**Project Name & Address:** 817-821 Williamson Street

**Application Type(s):** Certificate of Appropriateness for new construction in the Third Lake Ridge historic district

**Prepared By:** Heather Bailey, Preservation Planner, Planning Division

**Date Prepared:** August 11, 2020

**I SITE PLAN**  
C-1.1 1" = 10'-0"

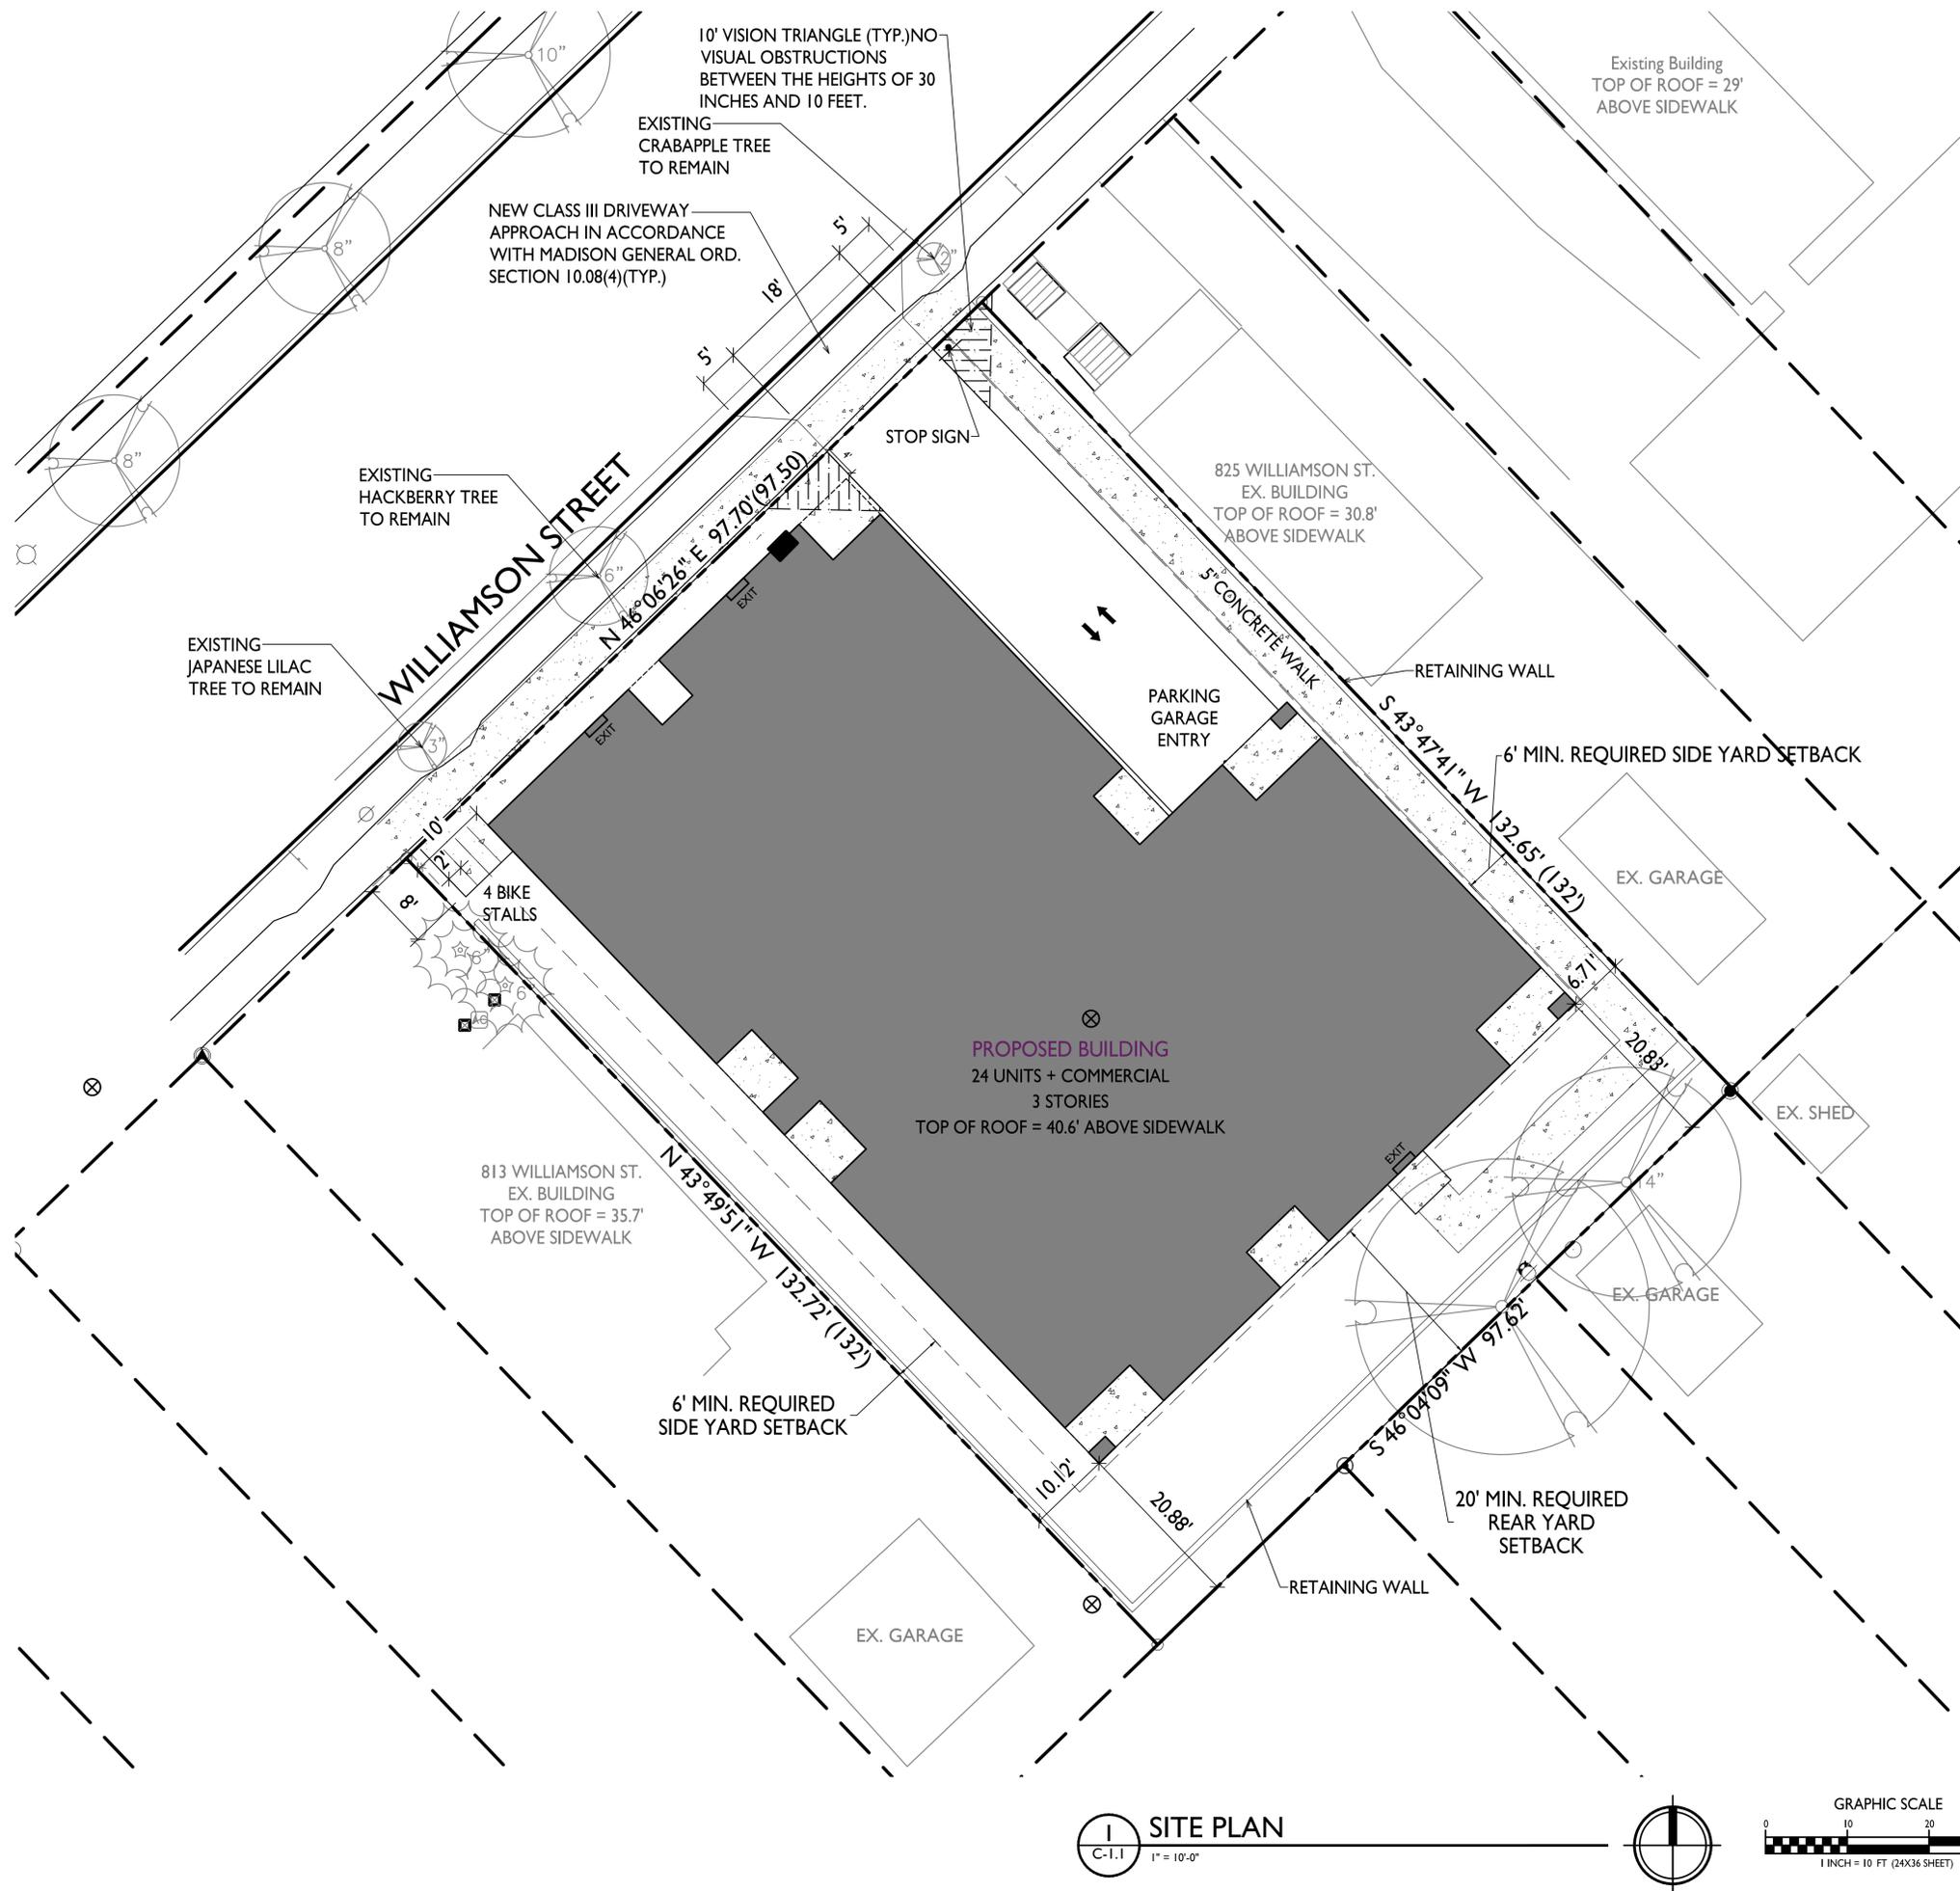
1. The ramp to access the structured parking is located on the side of the building and the garage door is on the side of the structure, making the access to the parking area minimally visible from the public right-of-way.

1. The garage door will be minimally visible from the public right-of-way, but should be of a compatible appearance with the structure and doors found in the district. Applicant should provide specifications on the garage doors.

1. Pedestrian door, garage door, and window specifications
2. Awning specifications
3. Lighting specifications
4. Information on locations for mechanical equipment on the roof and exterior walls of the structure
